IEC 62271-202
Edition 2.0 2014-03

High-voltage switchgear and controlgear –
Part 202: High-voltage/low-voltage prefabricated
substation

CORRIGENDUM 1

Figure AA.6 – Selection of tests on high voltage interconnections for class IAC-A

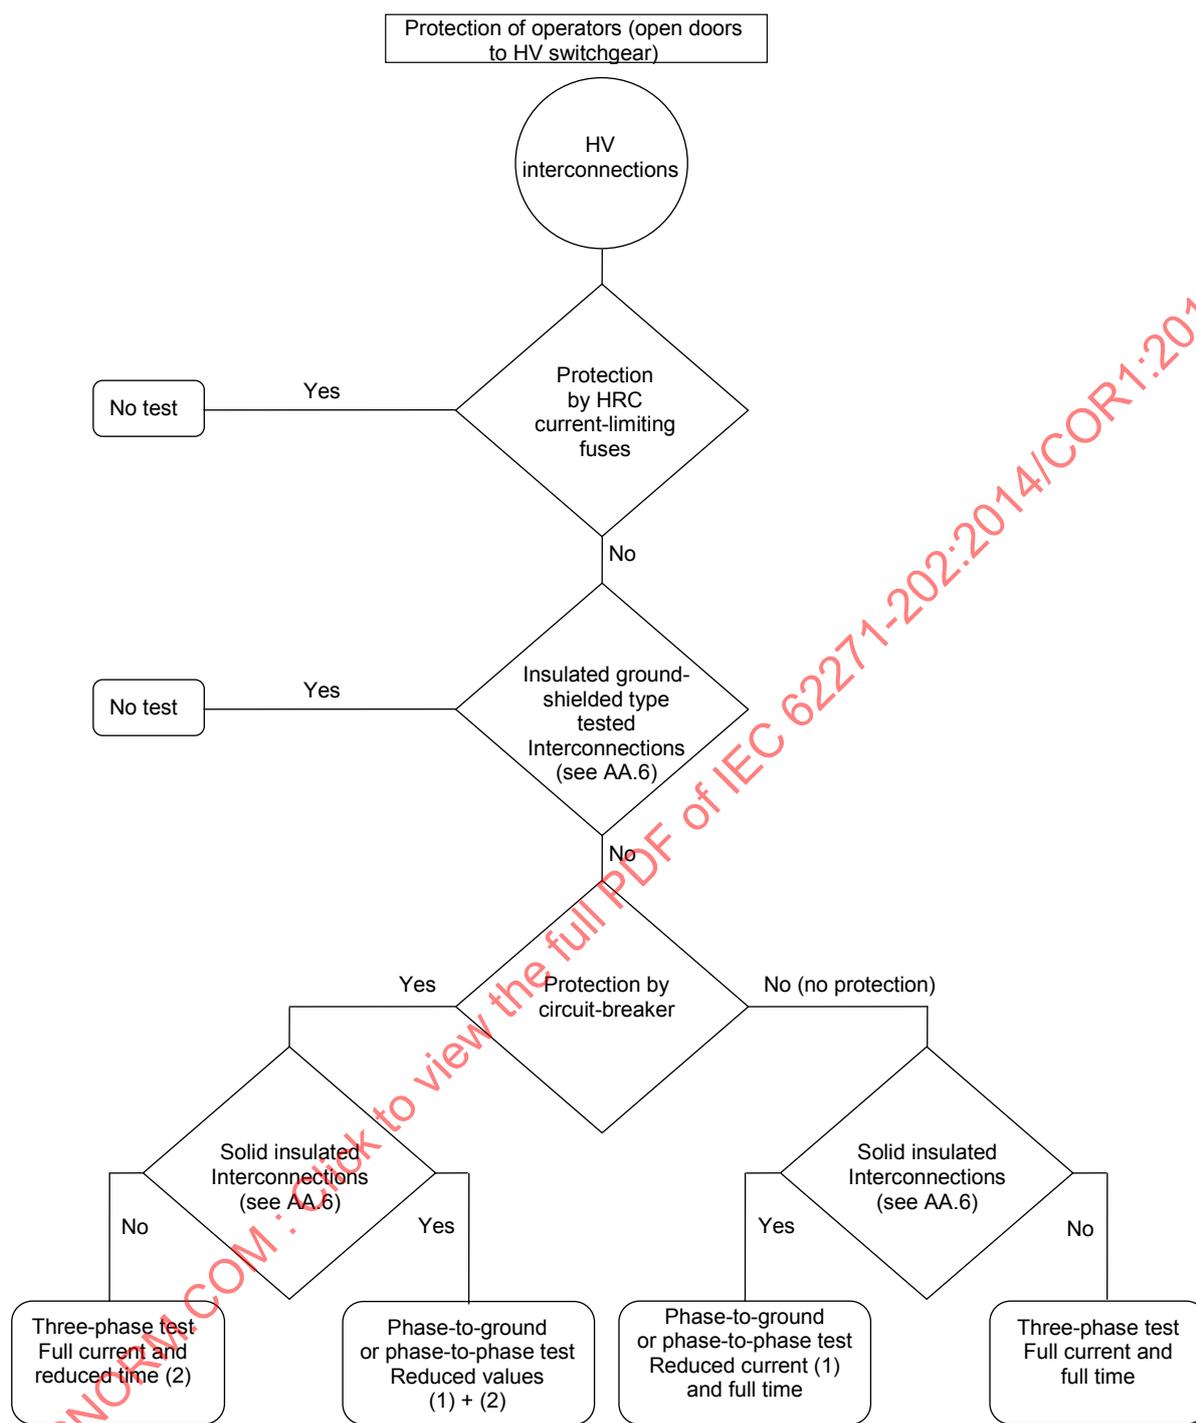
Replace the existing figure by the following new figure:

- * For phase to ground test the current value to be stated by the manufacturer.
- * For phase to phase test the current will be 87 % of the rated short-time withstand current.

(2) The time may be stated by the manufacturers, taking into account the time-setting of the protection.

Figure AA.7 – Selection of tests on high voltage interconnections for class IAC-B

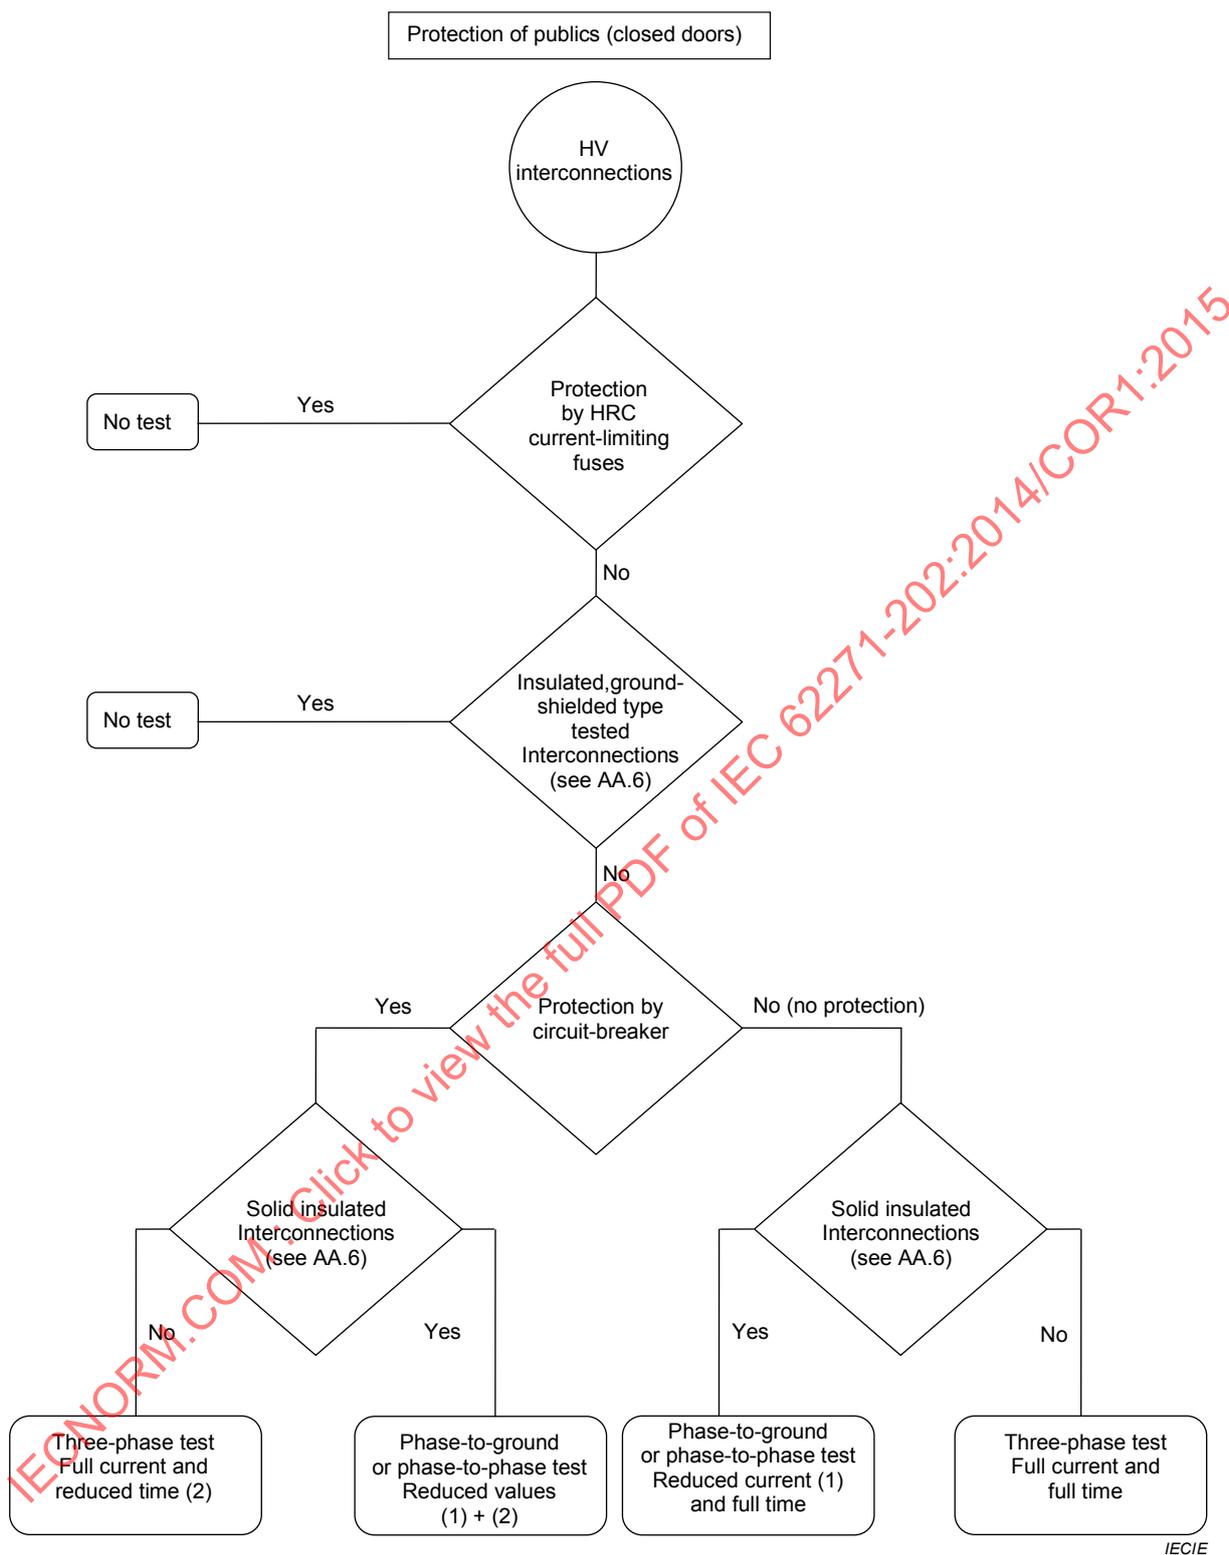
Replace the existing figure by the following new figure:

(1) Applicability of phase to ground or phase to phase test according to the criteria in AA.5.2.1 of IEC 62271-200:2011.

* For phase to ground test the current value to be stated by the manufacturer.

* For phase to phase test the current will be 87 % of the rated short-time withstand current.

(2) The time may be stated by the manufacturers, taking into account the time-setting of the protection.

Figure AA.6 – Sélection des essais sur les interconnexions haute tension pour la classe IAC-A

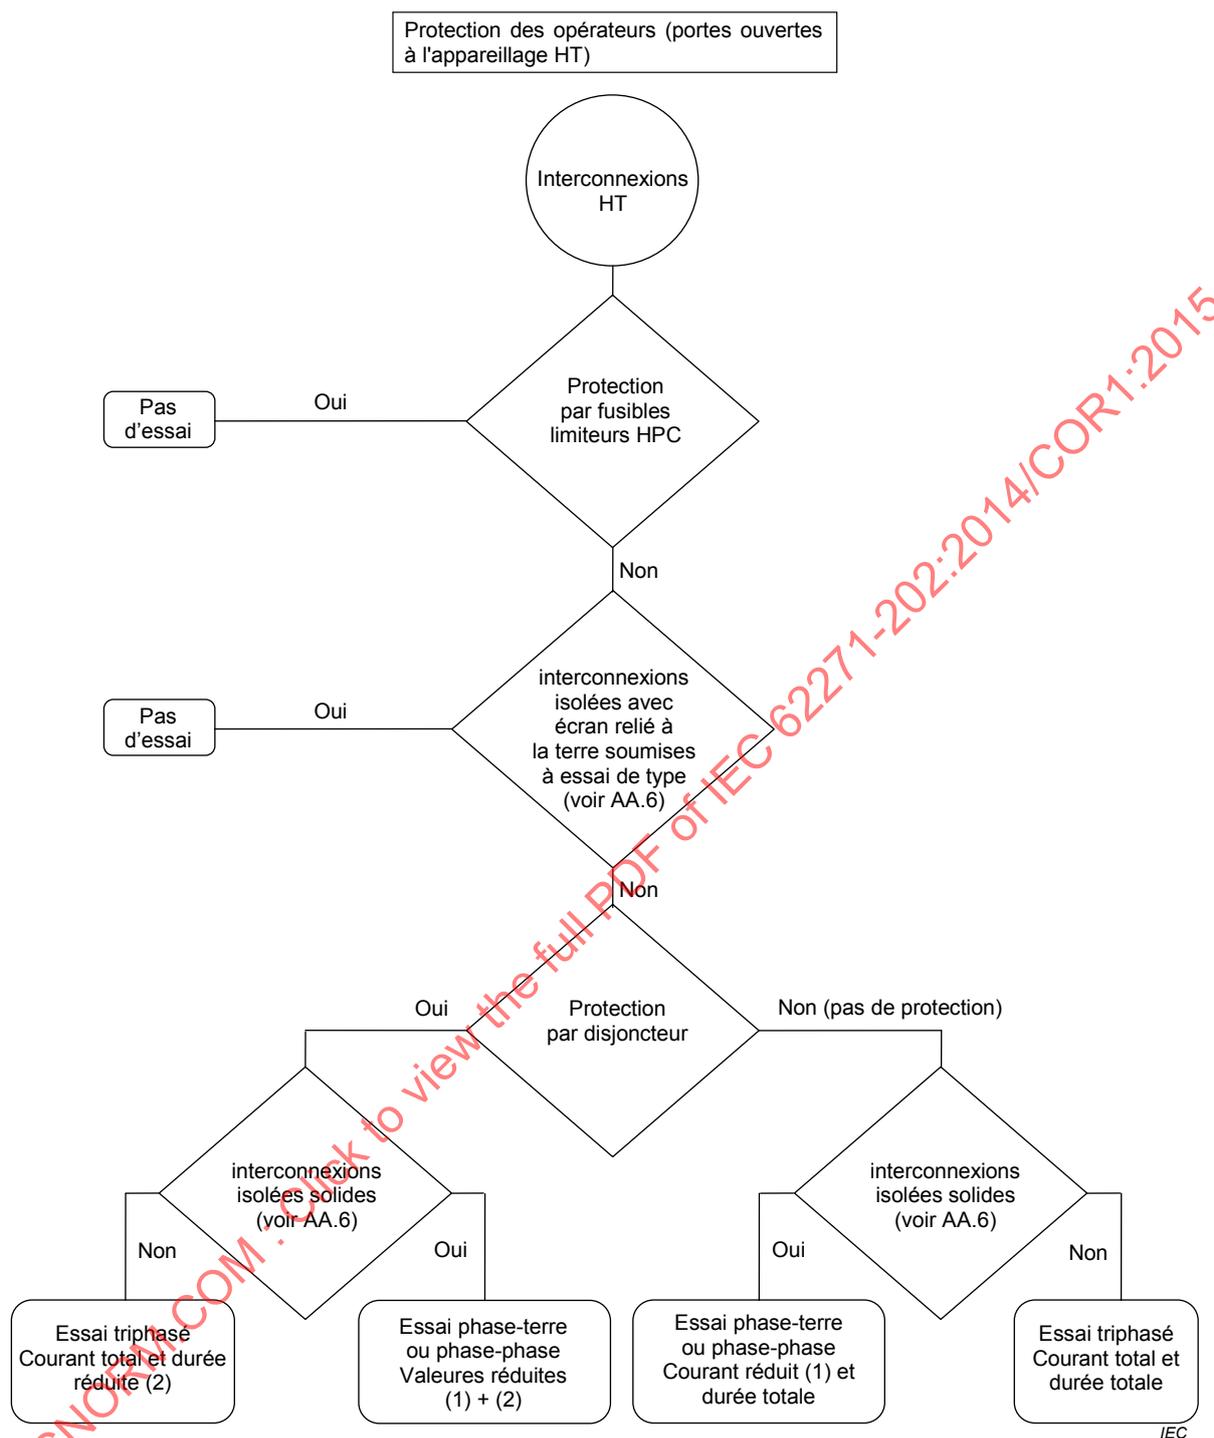
Remplacer la figure existante par la nouvelle figure suivante:

- * Pour l'essai phase-terre, le constructeur est tenu de spécifier la valeur du courant.
- * Pour l'essai phase-phase, le courant est 87 % du courant de courte durée assigné.

(2) La durée peut être déclarée par les constructeurs, prenant en compte le réglage en temps de la protection.
